RECEIVE AND FILE COMMUNICATION FROM THE PLAN AND ZONING COMMISSION REGARDING PRELIMINARY PLAT "HABITAT - E 46TH STREET" ON PROPERTY LOCATED AT 4320 E. 46TH STREET

Communication from the City Plan and Zoning Commission advising that at their April 20, 2023 meeting, the following action was taken regarding a request from Greater Des Moines Habitat for Humanity (owner), represented by Ryan Doyle (officer), regarding property located at 4320 East 46th Street, for the following:

PRELIMINARY PLAT - 2023 FOR HABITAT - EAST 46TH DEVELOPMENT CITY OF DES MOINES, IOWA

HABITAT - EAST 46TH DEVELOPMENT
 PRELIMINARY PLAT - TITLE SHEET
 SNYDER & ASSOCIATES, INC.

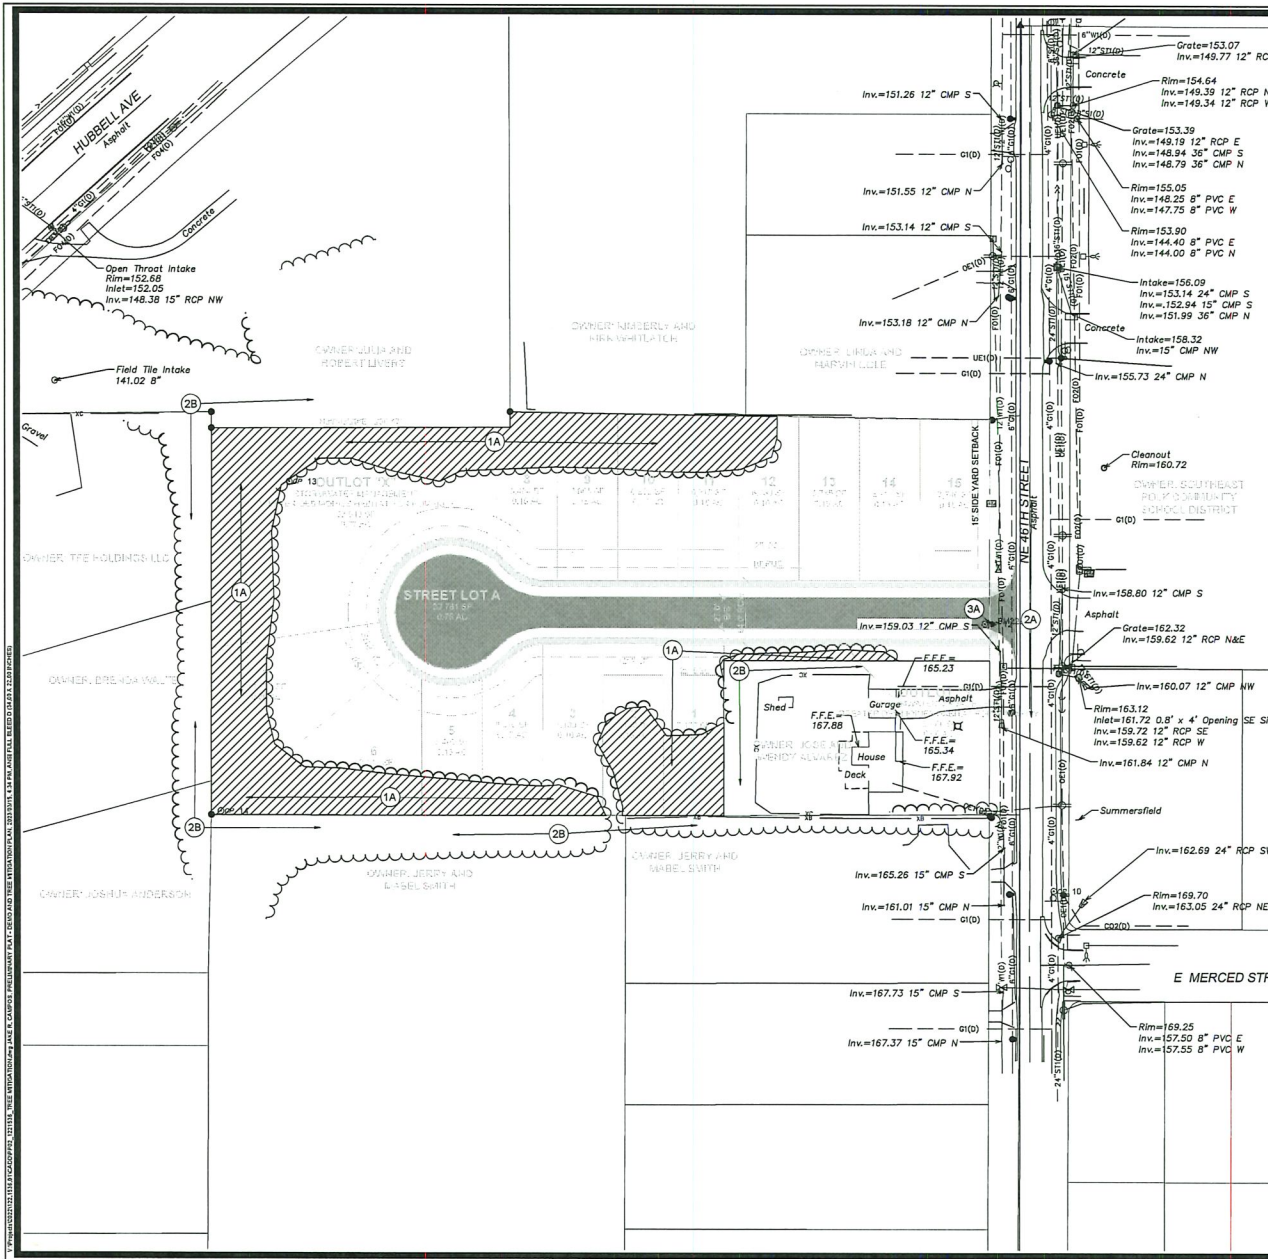
- A) Staff recommends approval of the Preliminary Plat "Habitat – E 46th Development," subject to the condition that a street stub connection be provided to the parcel to the southwest (Parcel #792321278015).

Allowing the currently proposed development concept would eliminate the potential connectivity to the adjacent undeveloped parcel to the southwest. Additionally, as sanitary sewer is being extended from the north for the proposed development, extending further access to the adjacent undeveloped parcel would likely be preferable over extending sanitary sewer access from Hubbell Avenue to the west. As stated within both PlanDSM and the Planning and Design Ordinance, site development should be pursued in a thoughtful manner that considers future land uses and encourages infill-style development patterns.

Staff supports the preliminary plat with the condition that a street stub connection be provided to the undeveloped parcel to the southwest to promote infill-style development and connectivity with the surrounding neighborhood.

Carol Maher asked where the stubbed street would be located.

Shawna Beron showed that the recommended stub would extend from the proposed cul-de-sac to the undeveloped lot immediately south of the subject property.

Chris Draper clarified the stubbed street would remove one lot from the proposed plan.

Bert Drost stated it would likely eliminate "lot 5" shown on the proposed plat.

APPROVAL of the Preliminary Plat "Habitat – E 46th Development," subject to the condition that a sewer easement be provided within the lots ensure future development upon the parcel to the south (Parcel #792321278015) could connect to the sanitary sewer within the proposed cul-de-sac.

Carolyn Jenison made a motion for approval of the Preliminary Plat "Habitat – E 46th Development," subject to the condition that a sewer easement be provided within the lots ensure future development upon the parcel to the south (Parcel #792321278015) could connect to the sanitary sewer within the proposed cul-de-sac.

HABITAT - EAST 46TH DEVELOPMENT
PRELIMINARY PLAT - GRADING PLAN
SNYDER & ASSOCIATES, INC.

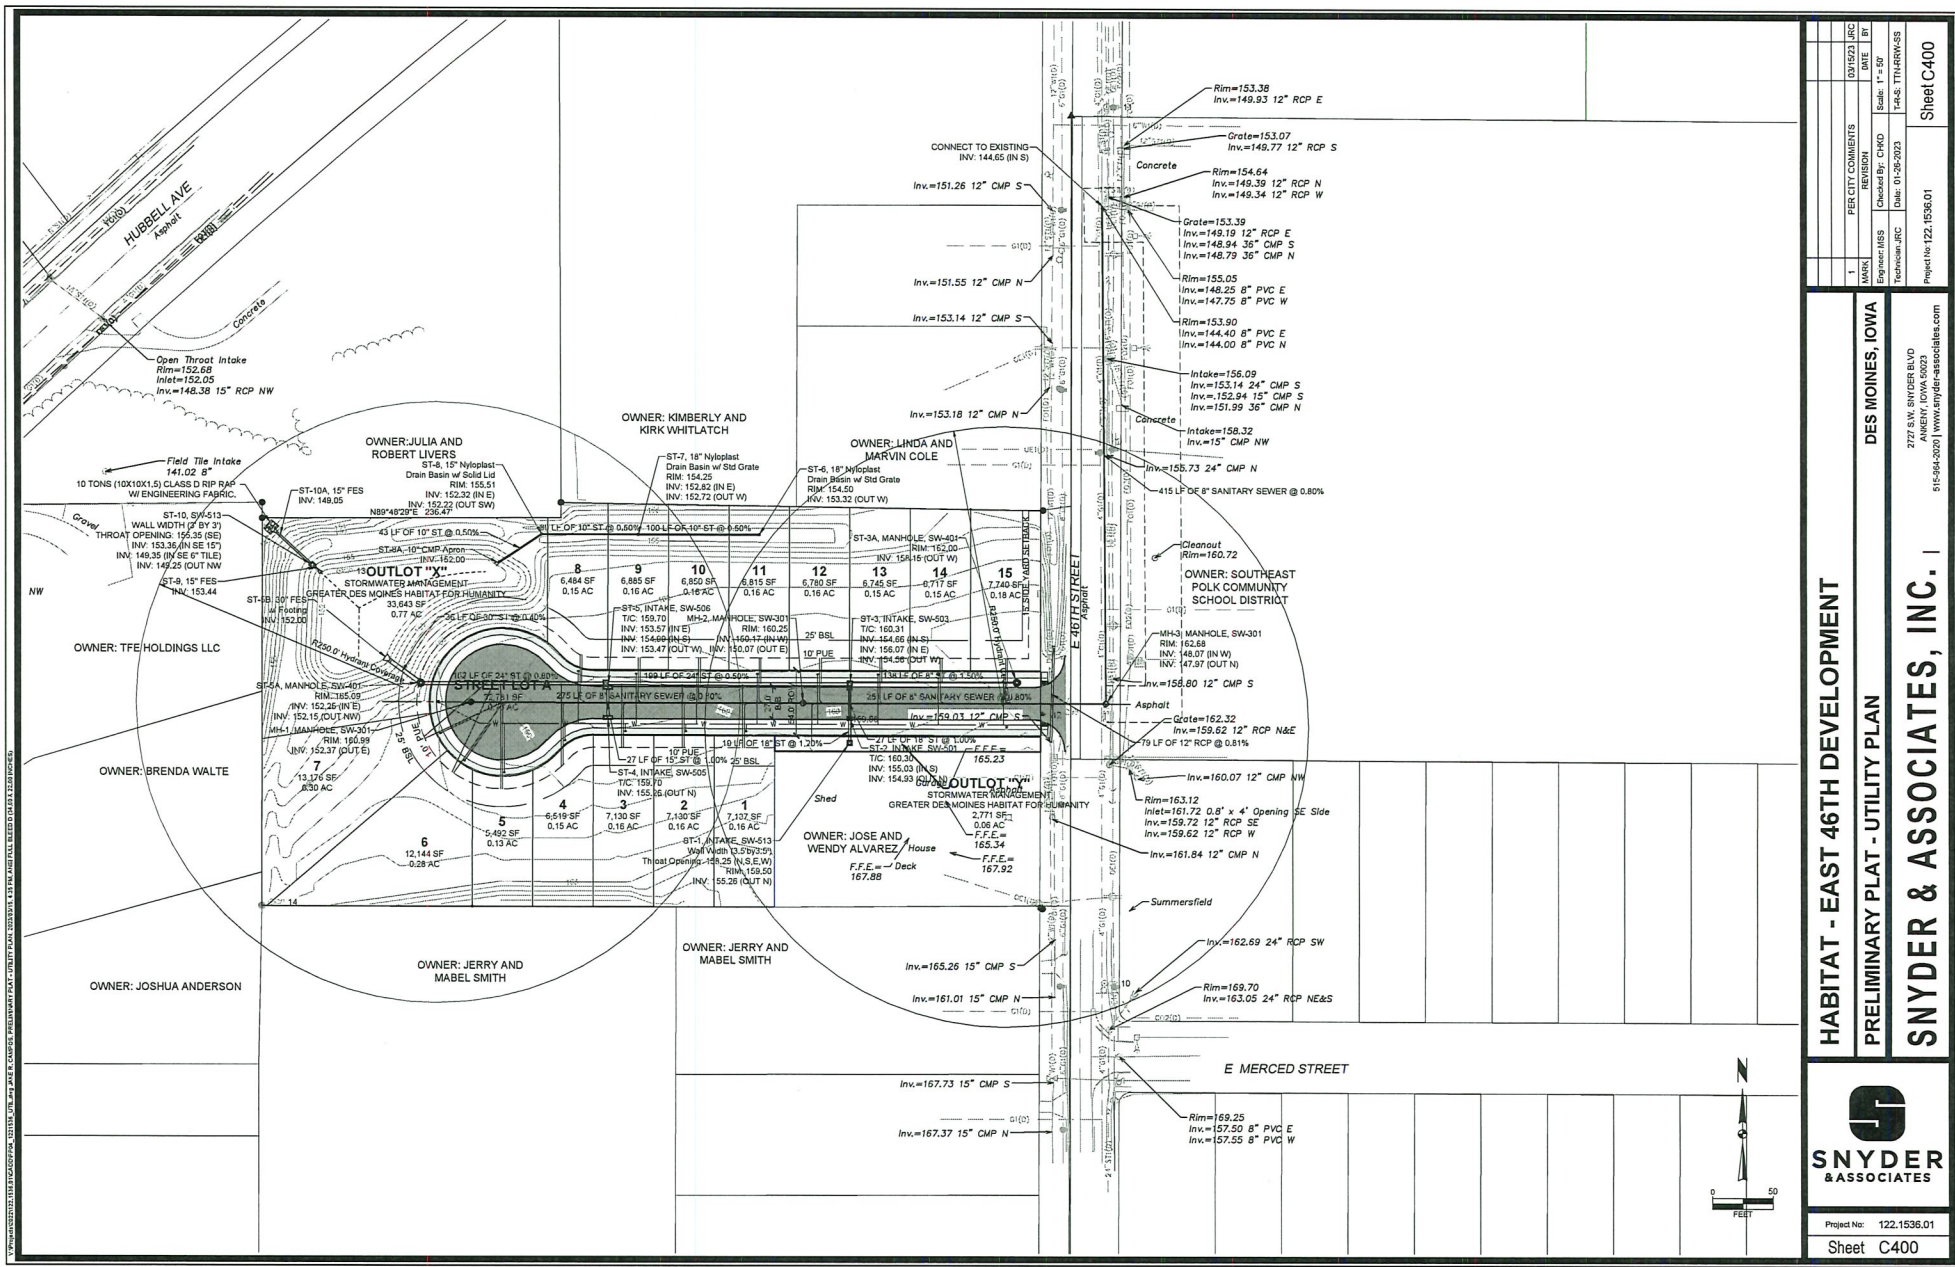
Shawna Beron stated that the northwest corner of the site is where they're proposing their storm water detention basin.

Chris Draper asked if the topography hinders the detention basin being placed on the southwest side of the development.

Tim West, Snyder and Associates, 2727 SW Snyder Blvd, Ankeny, IA. stated that the lowest portion of the property is in the northwest corner and that they're required to follow ISWIM guidelines set by Iowa Storm Water Management.

Leah Rudolphi asked if they are required to detain all storm water from the site so there is no net impact to surrounding properties.

Tim West stated they're required to bring the stie back to predeveloped release rates.

HABITAT - EAST 46TH DEVELOPMENT
PRELIMINARY PLAT - UTILITY PLAN
SNYDER & ASSOCIATES, INC. I

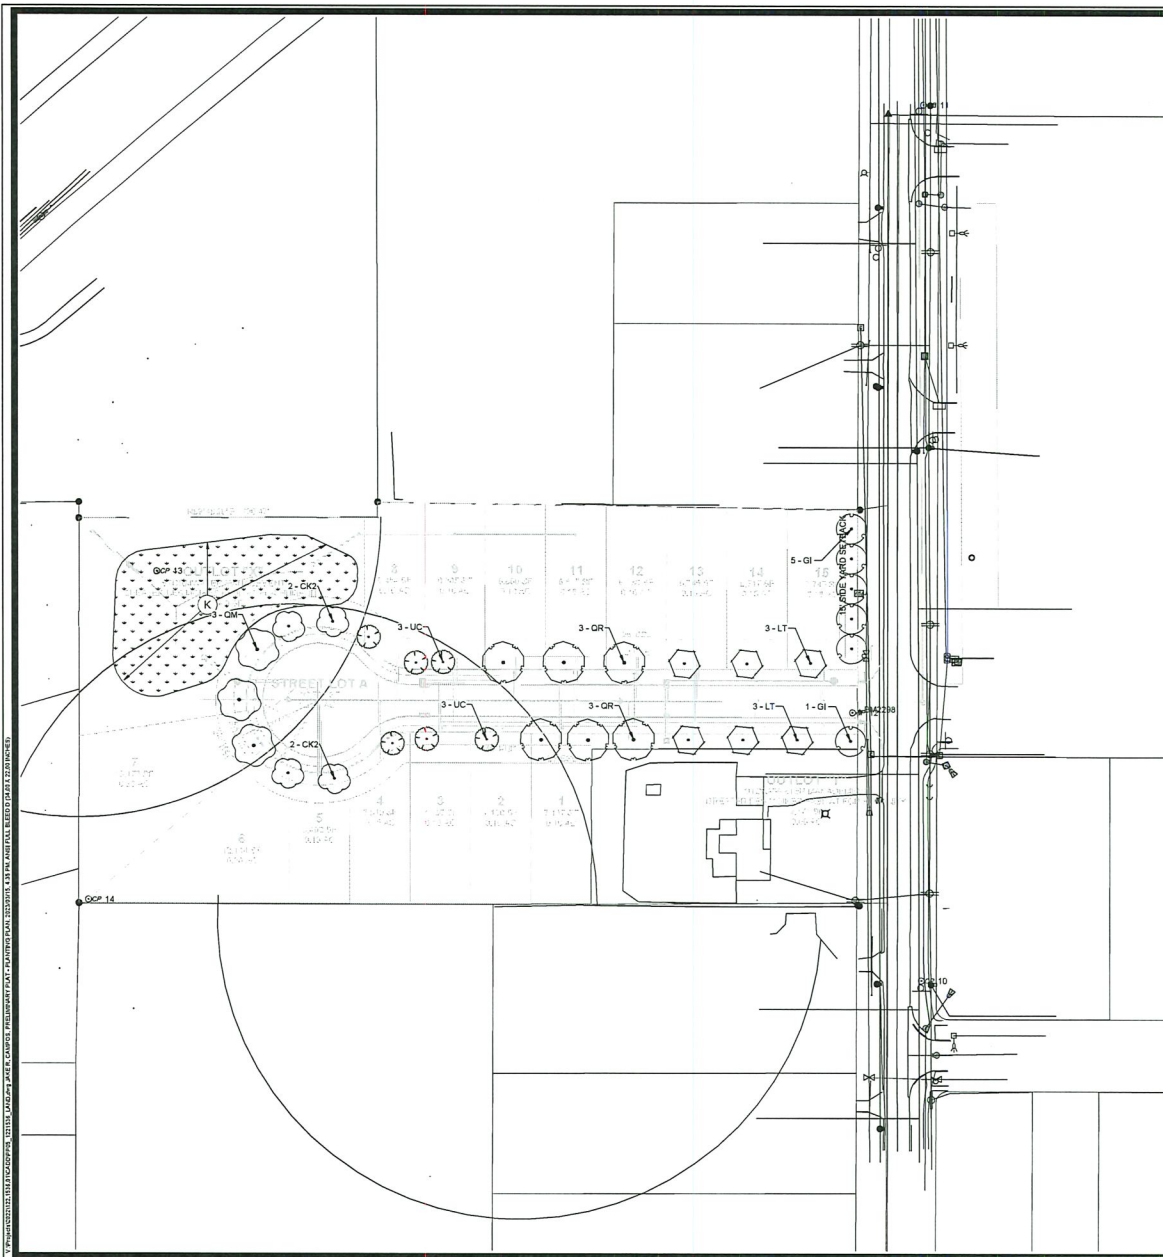
Lance Henning, Habitat for Humanity, 2200 E. Euclid Avenue, stated the proposed development would follow the general program with homeowners receiving education and financing through Habitat for Humanity. These houses would be built slab-on-grade with the provision of a garage. He also reminded the Commission that this property was in front of the Commission back in 2019, where they approved the use of a cul-de-sac. They would need to develop all 15 lots as there are financial challenges due to the cost of bringing sewer and water into the development. The south parcel is accessible from East 44th Street and Habitat would be willing to provide an easement for sewer connectivity.
